Office Action Summary

10/799,969

This is the first Office action for serial application number 10/799,969, Ornament Base, filed March 12, 2004.

Fig. 6

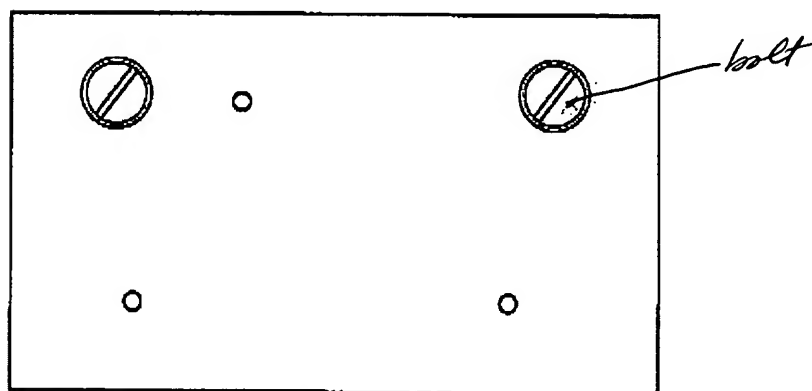
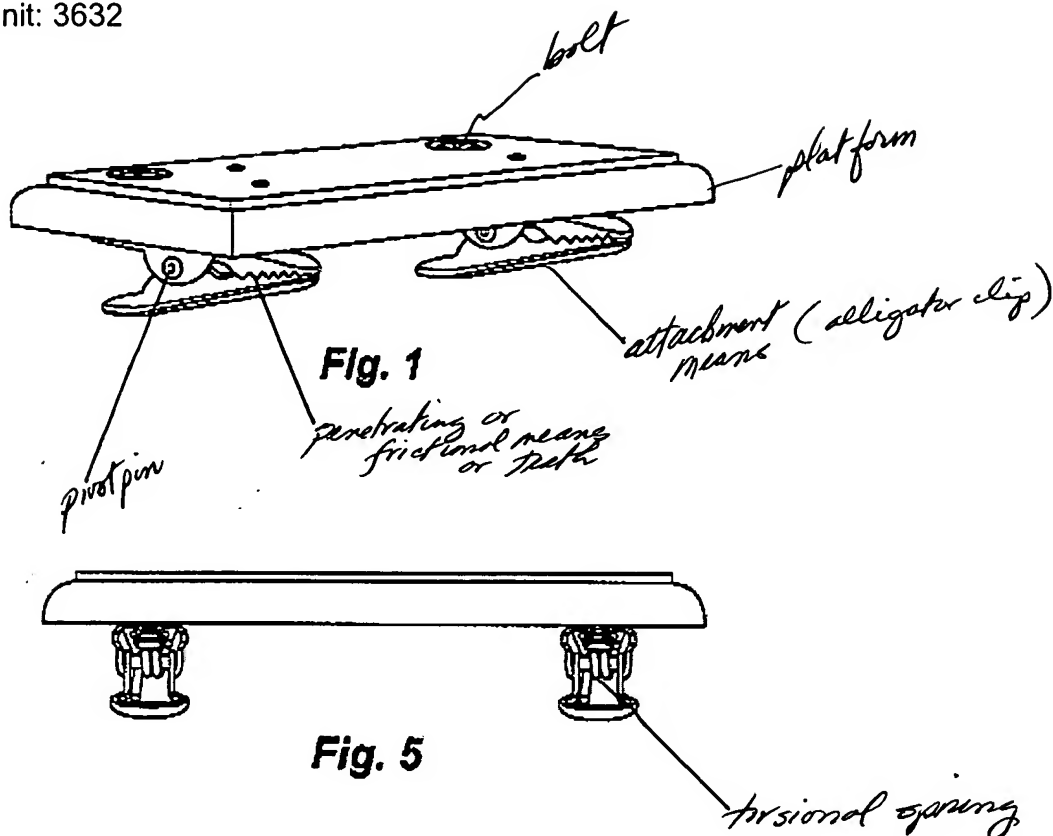
Claims 1-7 and 17-21 are rejected under 35 U.S.C. 102(b) as being anticipated by U.S. Patent No. D450,620 to Simpson. The present invention reads on Simpson as follows: Simpson teaches an apparatus for supporting and displaying an object. The apparatus comprises a platform, and at least one attachment means. The platform is adapted for supporting the object; and the at least one attachment means is for interacting with a generally horizontal projection upon which the object is displayed. The attachment means is removeably attached to a bottom surface of the platform. The at least one attachment means has a first end and a second end. The first end of the at least one attachment means comprises opposite, opposing jaw members biased towards one another. The second end of the at least one attachment means comprise legs that when forced together separate the opposite, opposing jaw members. The jaw members of the at least one attachment means is connected by a pivot pin and is biased towards one another by a torsional spring. The jaw members contain penetrating or frictional means to prevent the platform from rotating about the generally horizontal projection. The penetrating means are teeth. The at least one attachment means is an alligator clip. See figures below.

Since the method is predicated upon the structural recitations, the method is inherent.
